Planning Objection – Lissinagroagh Wind Farm (Noise, Landscape & Policy Consistency)

To: An Coimisiún Pleanála / Relevant Planning Authority

Re: Proposed Lissinagroagh Wind Farm Development, Co. Leitrim

Current View from N16:

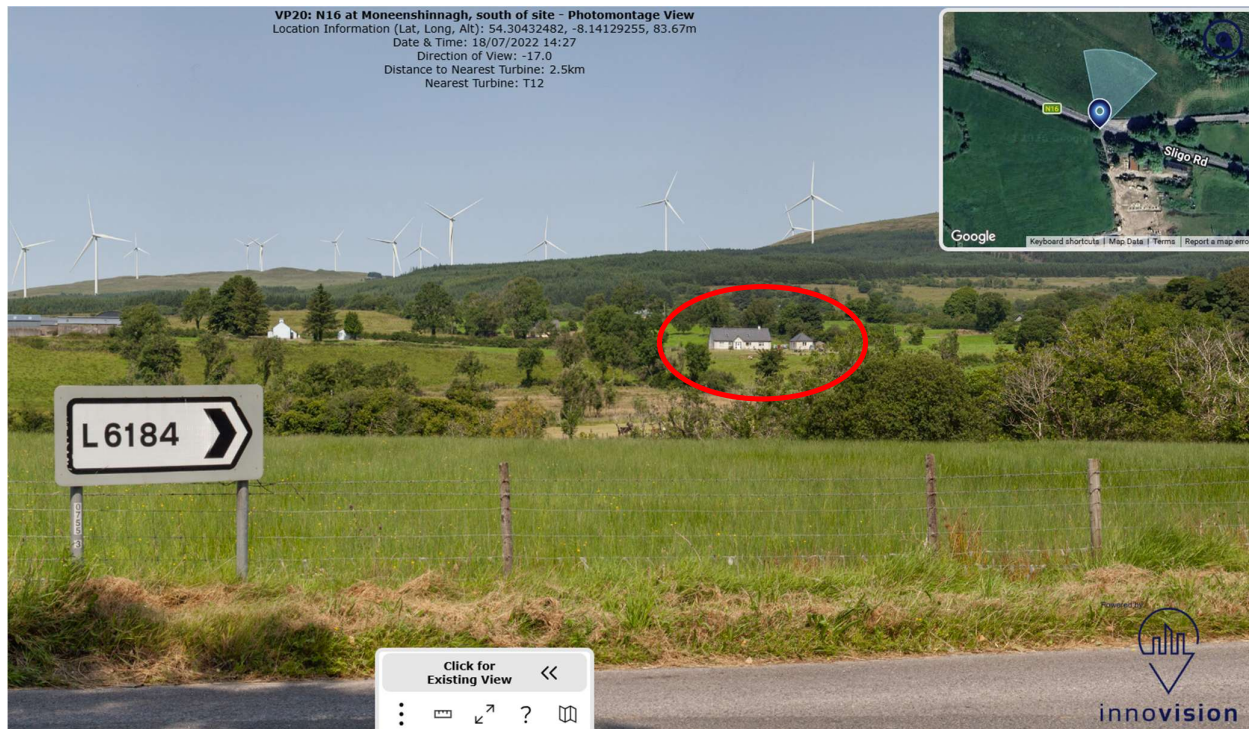
Proposed: Lissinagroagh Wind Farm added

- My house shown encircled

- **Dominate the skyline**
- Be visible over wide distances
- Introduce continuous motion and night lighting

- **Significant visual intrusion**
- Loss of rural landscape character
- Transformation of the area into an **industrial-scale environment**

Appendix 1

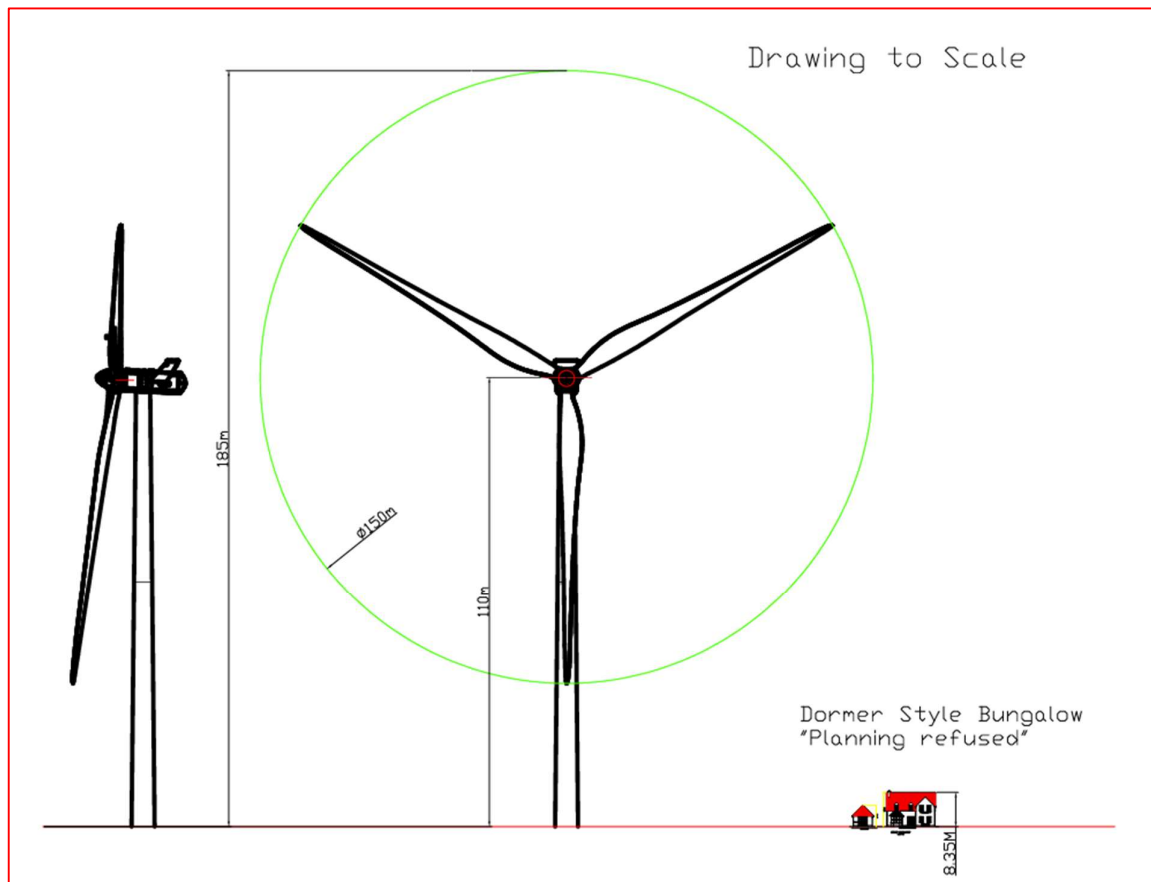
- A modest dwelling of **8.35m** was deemed unacceptable. See **appendix 1** below for visual scale.
- Yet structures almost **30 times higher** are now proposed. Among the tallest turbines in Ireland/Europe.

- Planning Reference: **P03449**. Dormer style bungalow @ 8.35m refused.
- Advised dwelling not exceeding 6.5M in height would be appropriate to the site.
